SITE PLAN REVIEW

Wisconsin Stamping & Manufacturing / American Architectural Group

Village Planner Report

To: Jeffery W. Retzlaff, ACIP, Village Planner/Zoning Administrator
From: Eric Bartlein, Civil Engineer
CC: Larry Ratayczak, Director of Public Works; John Laning, Village Engineer
Date: April 5, 2017
Re: Wisconsin Stamping Proposed Addition Plan Review

WISCONSIN STAMPING – BUILDING ADDITION
UTILITY PLAN
DATED: MARCH 6, 2017
C-103
QUAM ENGINEERING, LLC
Residential and Commercial Site Design Consultants

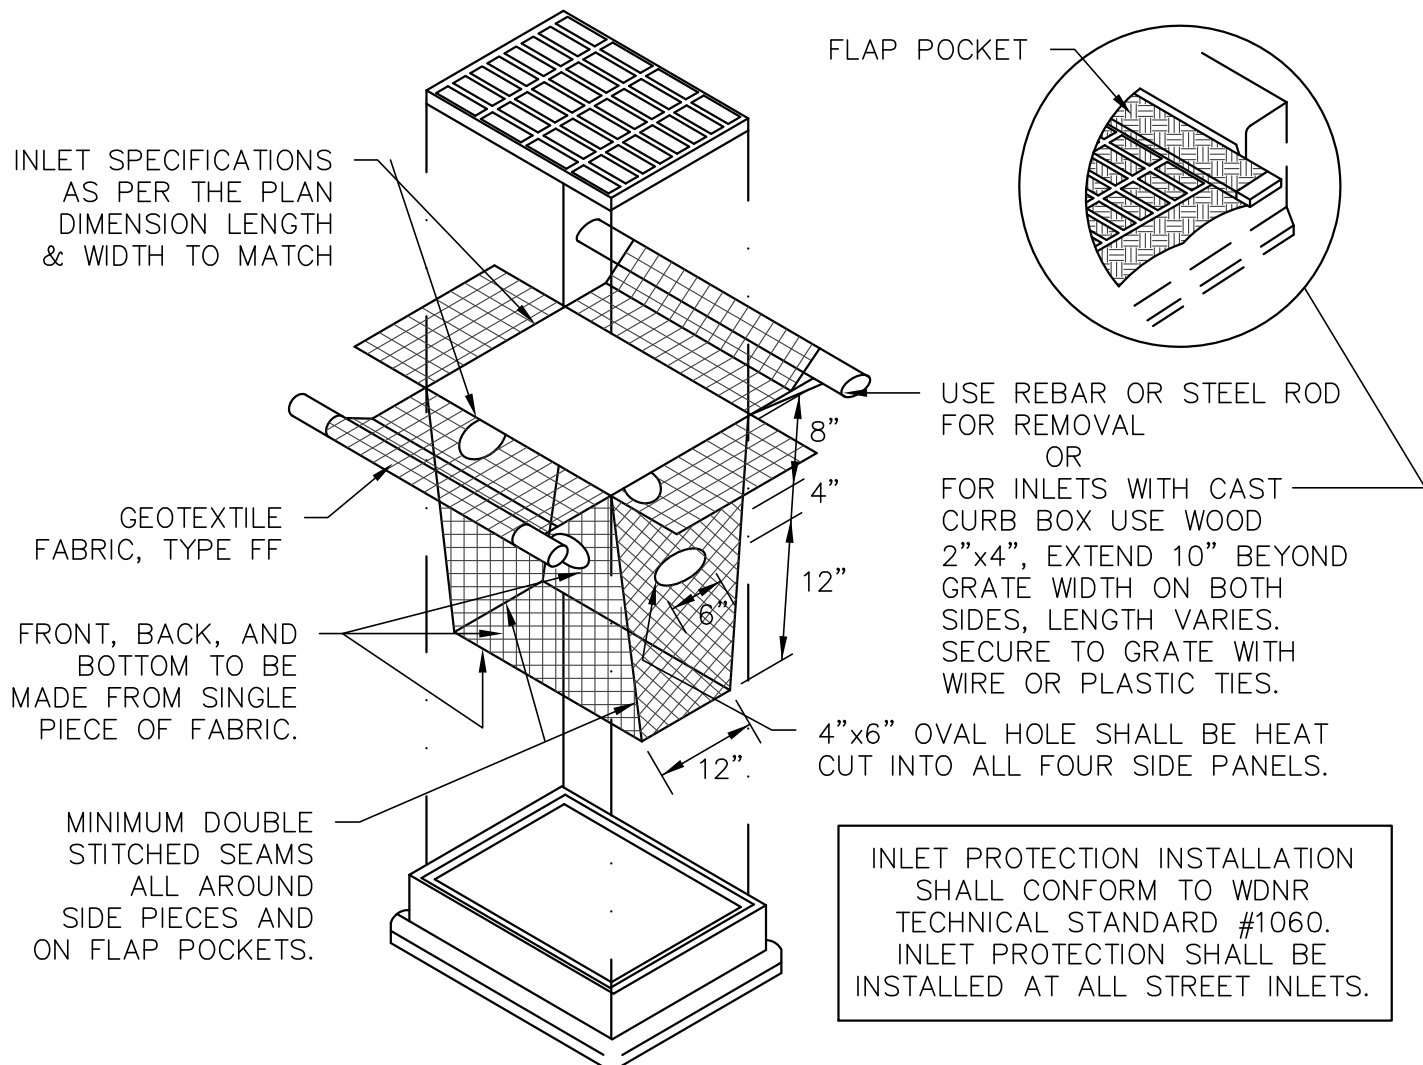
Utility Plan – C-103

- Extend the 20' water main easement over the new water main.
- As-built will be needed for the water main extension.
- In the last paragraph in the Utility Notes change "Village of Grafton" to Village of Germantown.

SITE DETAILS

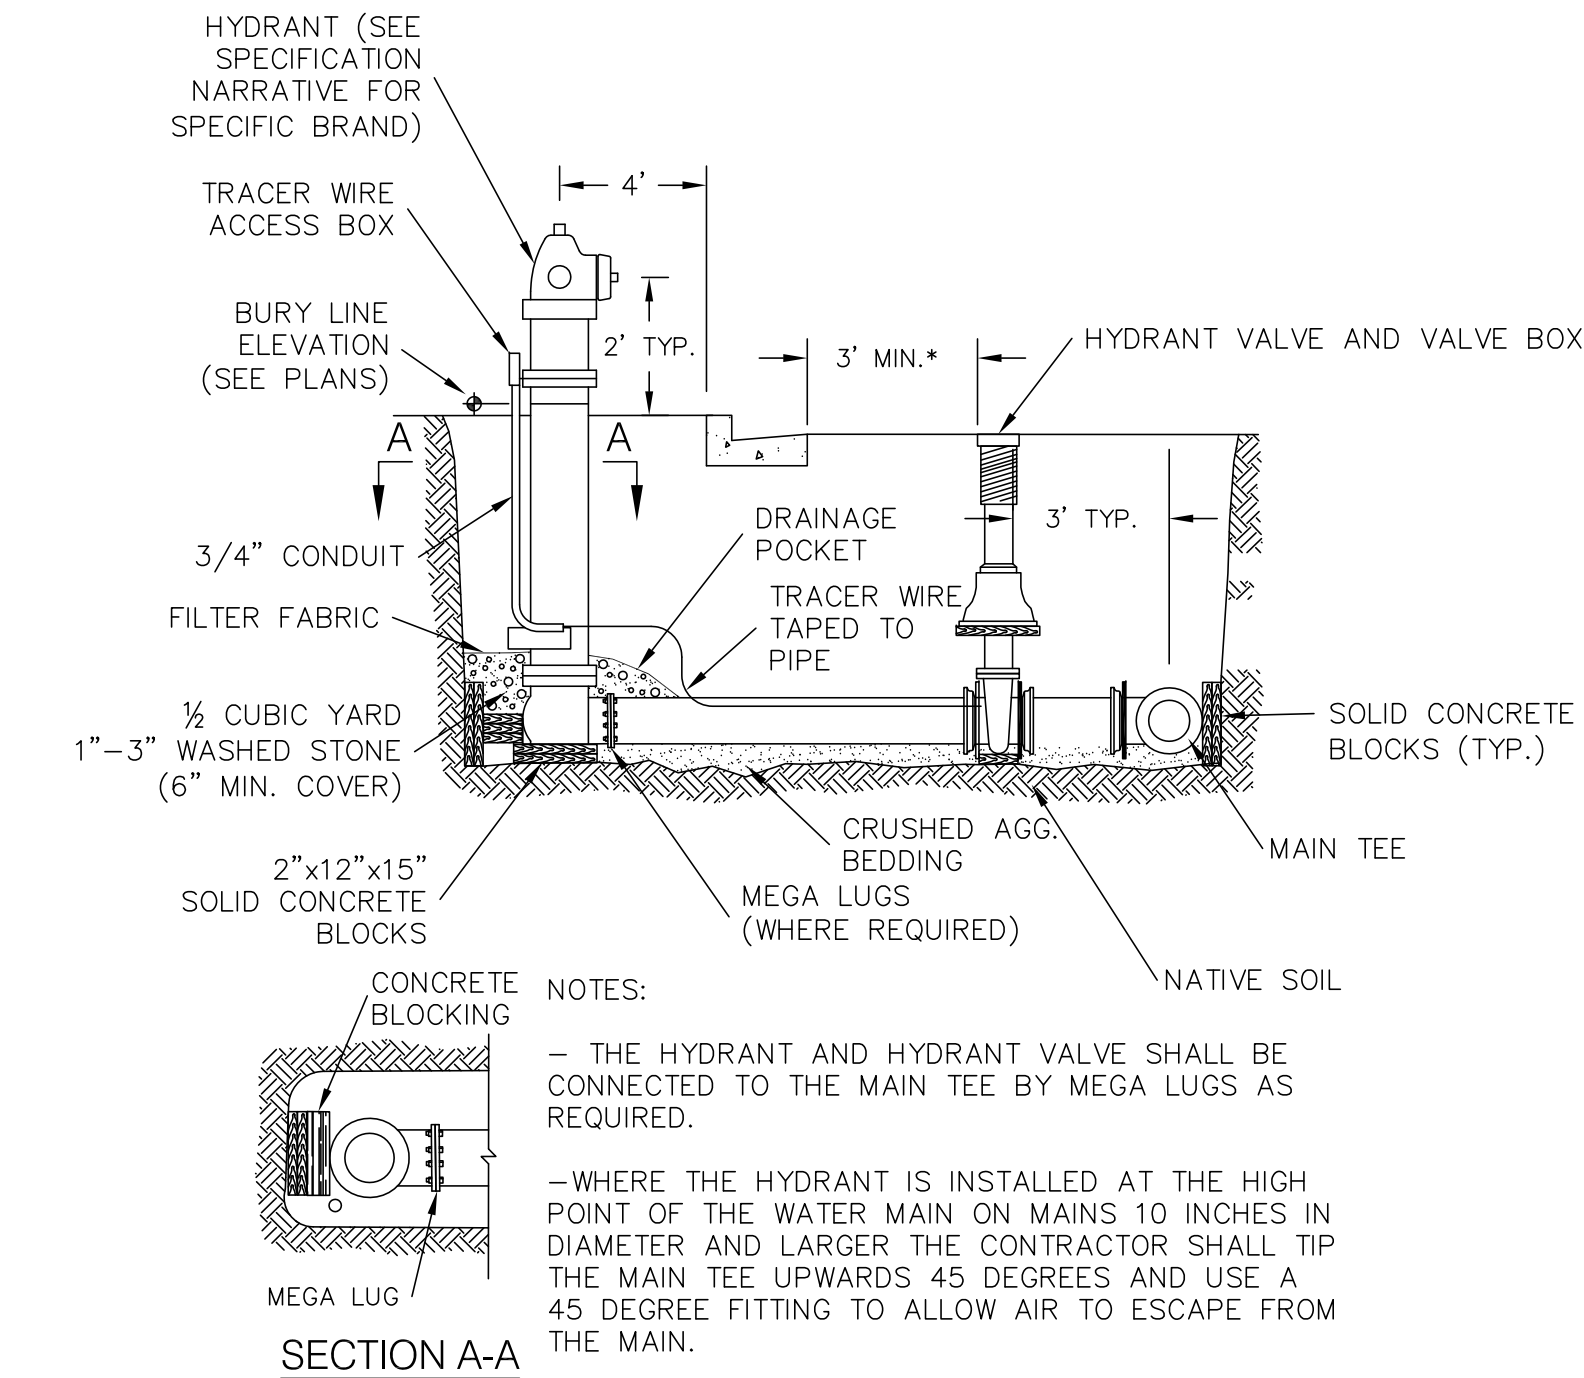
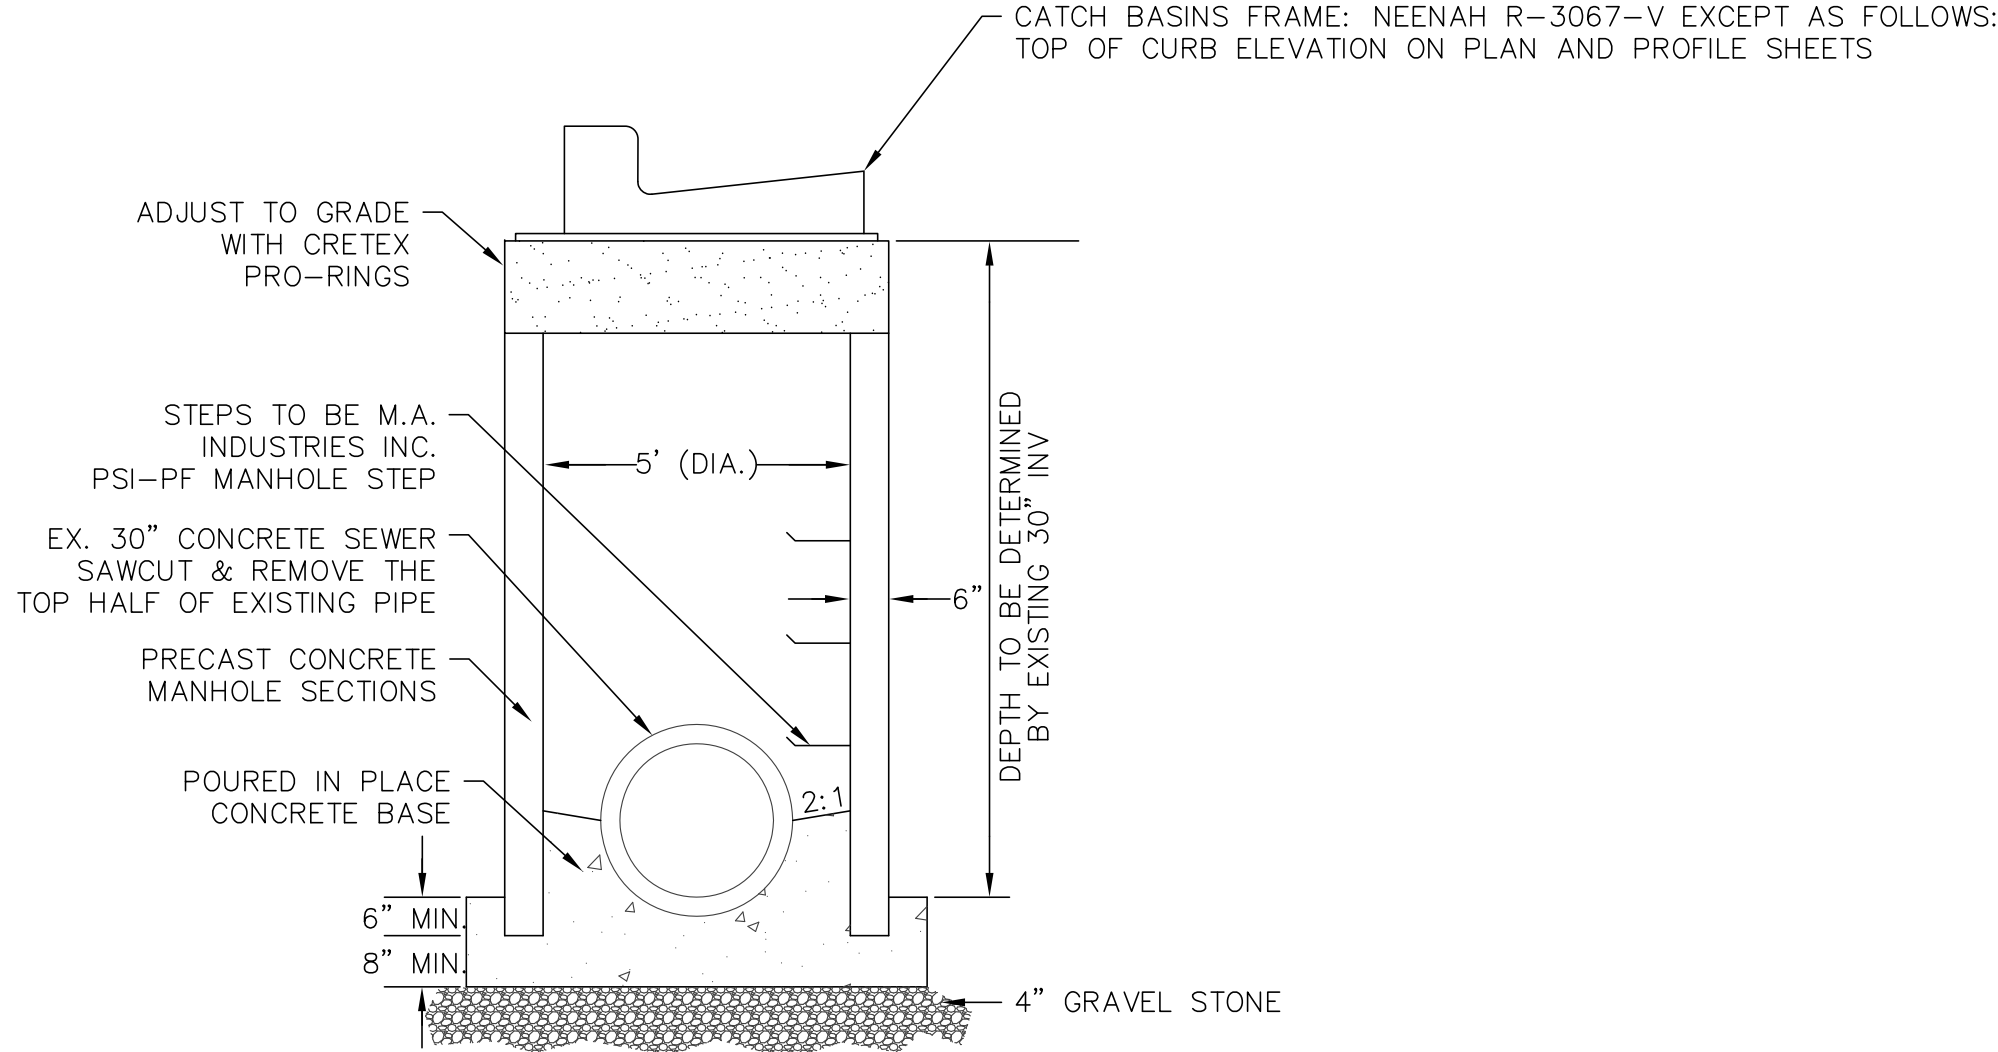
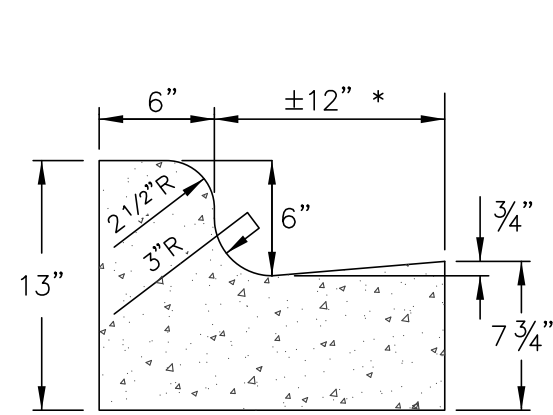
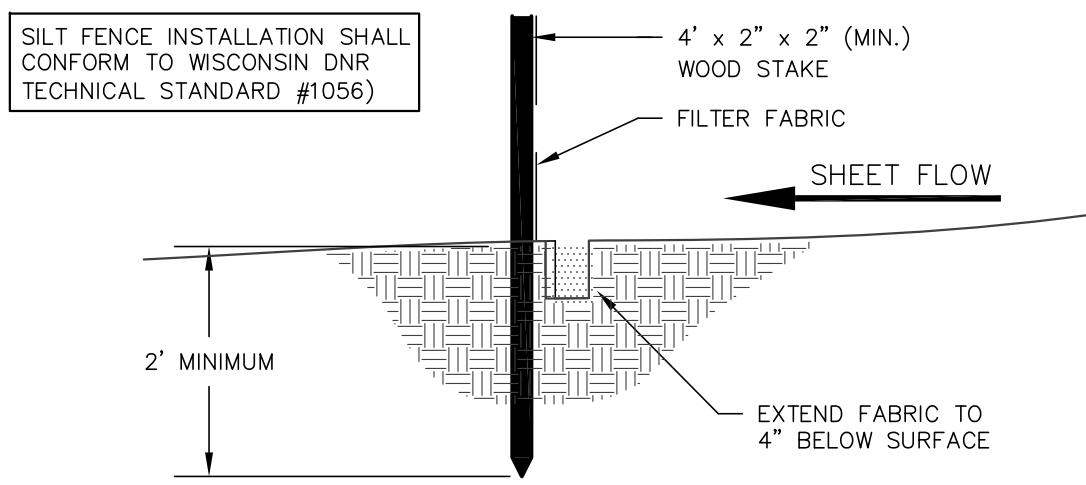
Site Details – C-104

- Water Distribution System – Line 3 – change the "Standard Specifications" to Village of Germantown's Standard Specifications.
- Water Distribution System – Line 4 – add "Village of" in front of "Germantown Standard Specifications".
